01-AFC-4
CALIF ENERGY COMMISSION

May 7, 2001

Subject: East Altamont Energy Center Application for Certification
Data Adequacy Response Set 3

EAST ALTAMONT ENERGY CENTER DATA ADEQUACY RESPONSE SET 3

Table 4 -2005 HS Case with EAEC, **Two Lines** from EAEC to Westley
PRKR MID-Parker 1M #1 Outage

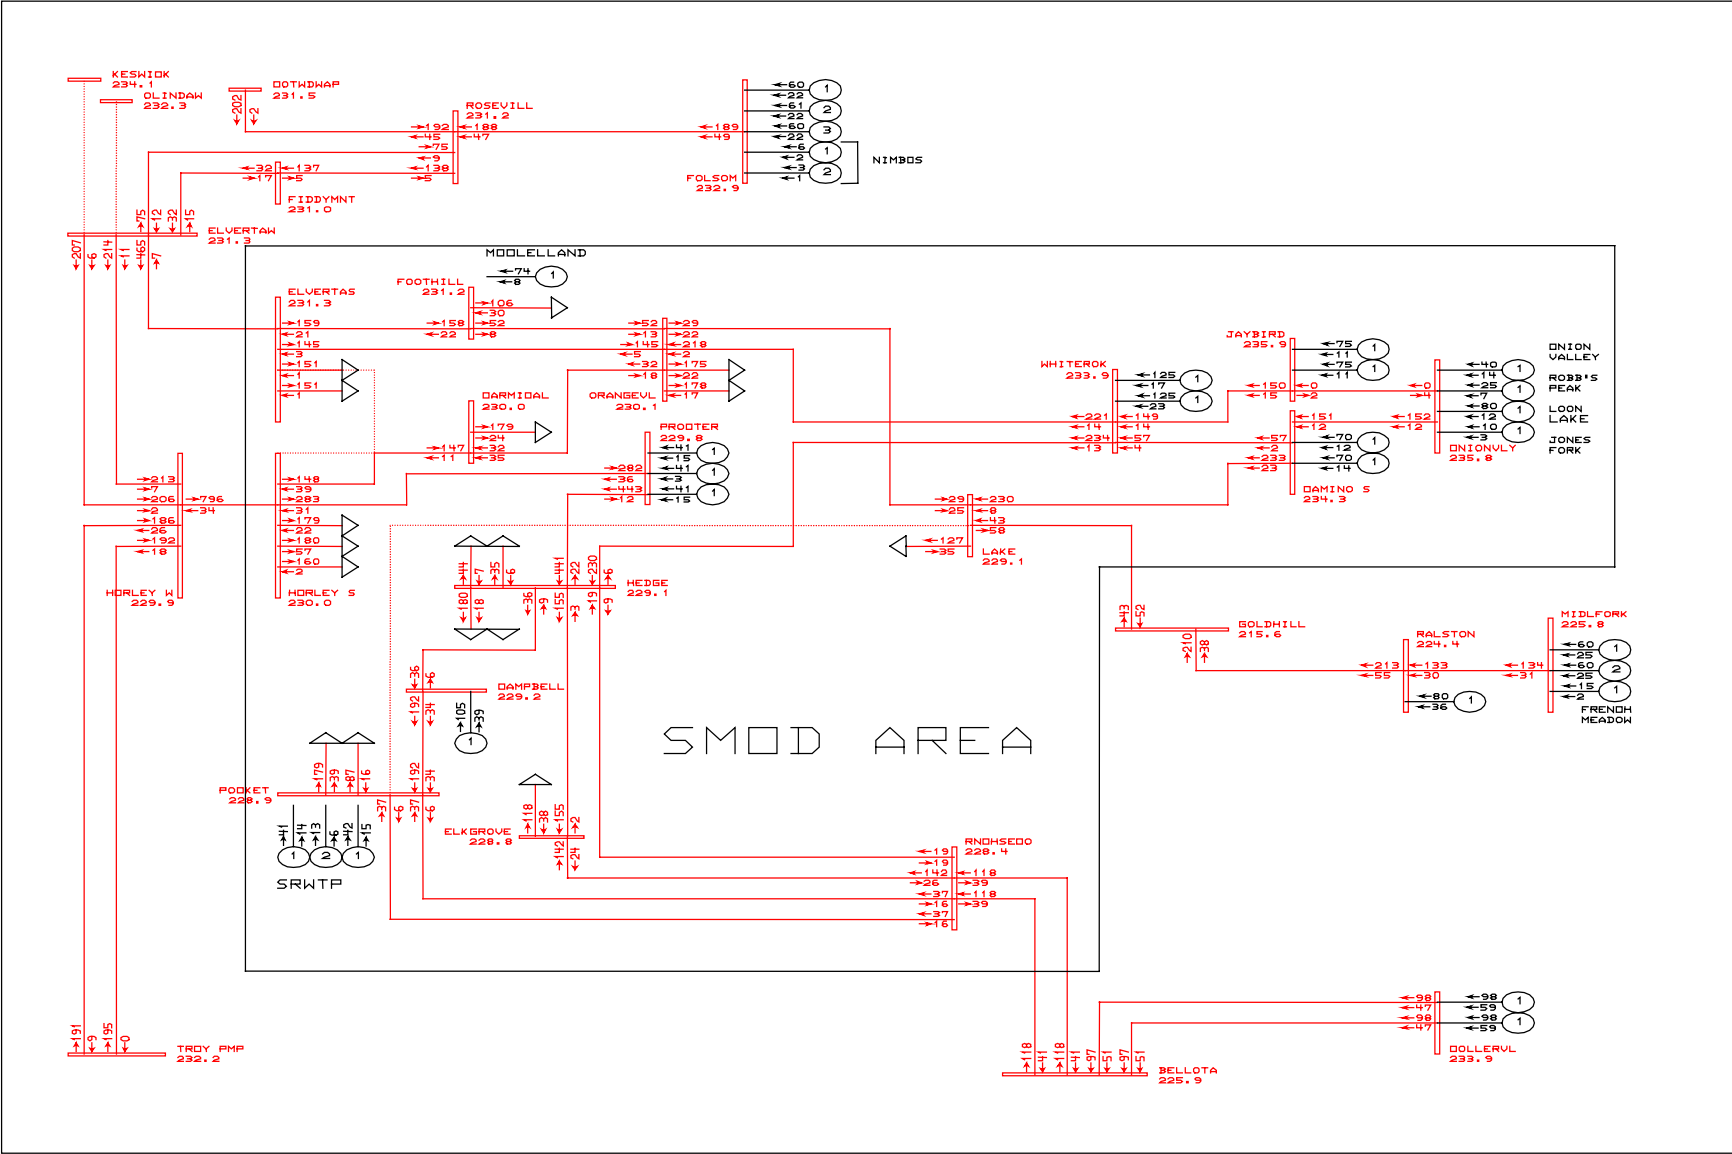
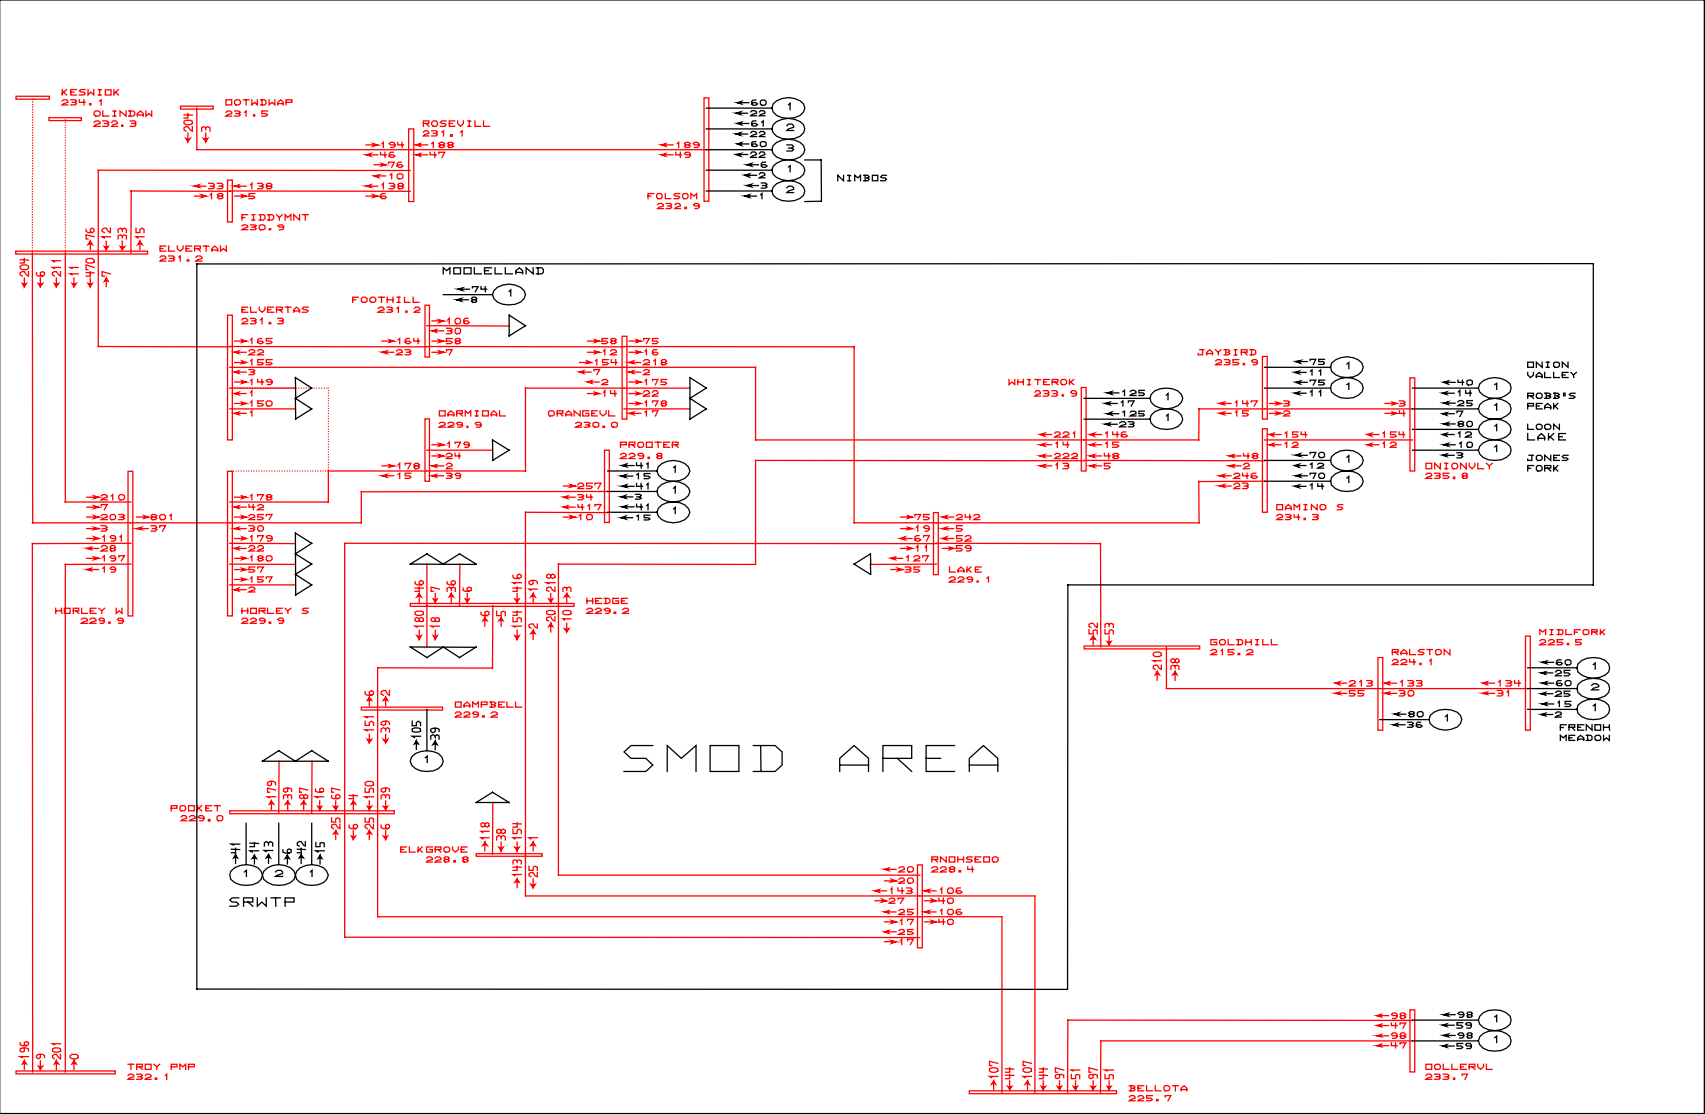
Data Adequacy Deficiency – Provide power load flow diagrams which demonstrate conformance or non conformance with utility reliability and planning criteria.

Provide a System Impact Study per the study plan of Appendix 5.4-A.

Data Adequacy Response – The power load flow diagrams prepared by Western Area Power Administration are attached as TSE-2. The attached power flow drawings are drawings of the base cases and the outages for each of the cases, which correspond to Tables 2, 3 and 4 in the System Impact Study submitted on May 2 in EAEC LLC's Data Adequacy Set 1.
